SUBJECT: Notification of Elevated Review
Quaker Valley School
Permit Application No. PAD020098
Sewickley Borough, Allegheny County

Permit Application Timeline

After reviewing the response to our Technical Deficiency Letter, the referenced application for Individual NPDES Permit still contains significant technical deficiencies. The following is a list of the deficiencies that remain:

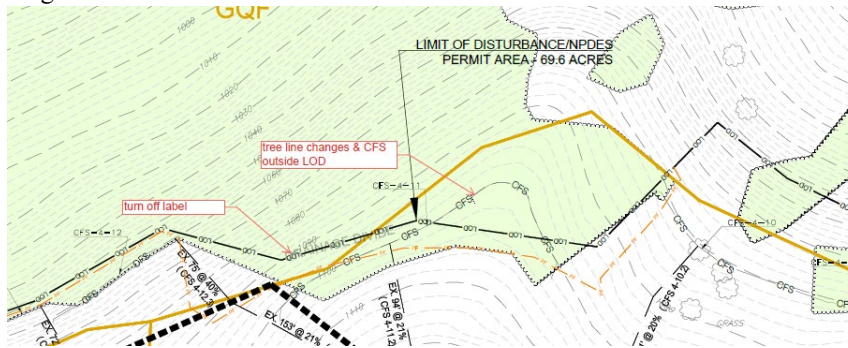
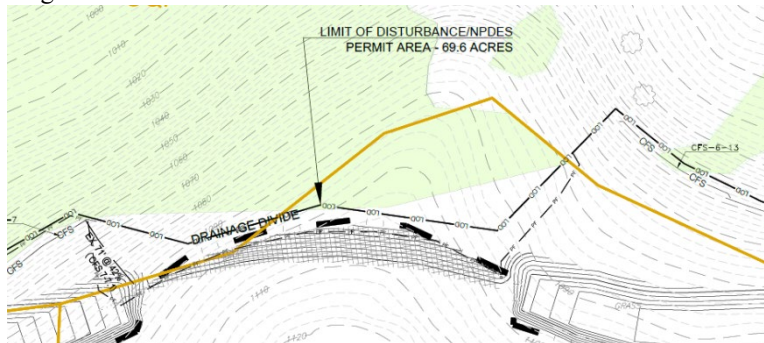
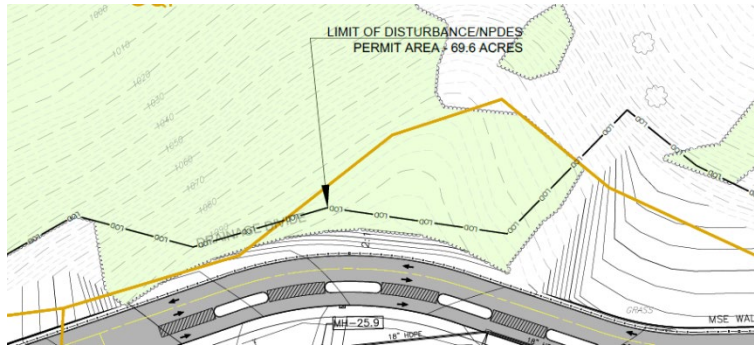
230. §102.4(b)(5)(viii), & §102.4(b)(5)(ix): Please explain why a keyway has not been provided for the basin embankment. Please respond.
231. §102.4(b)(5)(ix): Trees are being removed and replaced outside the LOD limits between the stages (see screenshots below). Compost filter sock is depicted outside the LOD line during Stage 4. An earlier stage “Drainage Divide” label is also still depicted within the Stage 4 drawings. Please revise to read/depict consistently.

Stage 2 – Stockpile up top, Sediment Basin 1 installation, Diversion channel DV-1 with Rock Filter RF-1, RCE #2, concrete washout

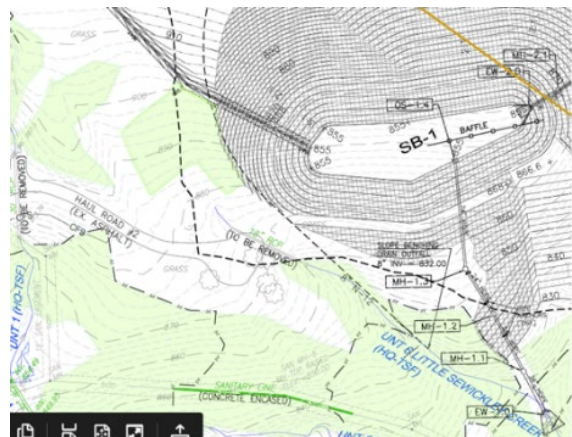
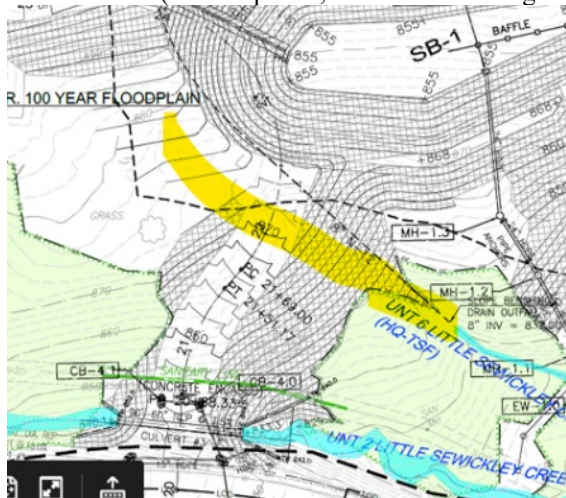
248. §102.4(b)(5)(i): Pages are out of order. Sheet ESC102D is the first page of the series but is labeled as sheet 4 of 4 on the cover sheet.

249. §102.4(b)(5)(v): Consider adding perimeter controls on the S/SE site of the topsoil stockpile on page ESC102D.

250. §102.4(b)(5)(v): The layer showing the floodways for the watercourses are not shown in Stage 2. Please add this layer to this set.

251. §102.4(b)(5)(ix): No CFS is shown in the area where grading will occur for the basin or channel. (Previously CFS #15 was provided.) Similarly, it does not appear that any of the sections of CFS in the calculations pertain to this location indicating that now nothing is proposed to manage sediment laden runoff from the grading activity. Perimeter controls should be provided for the grading required to
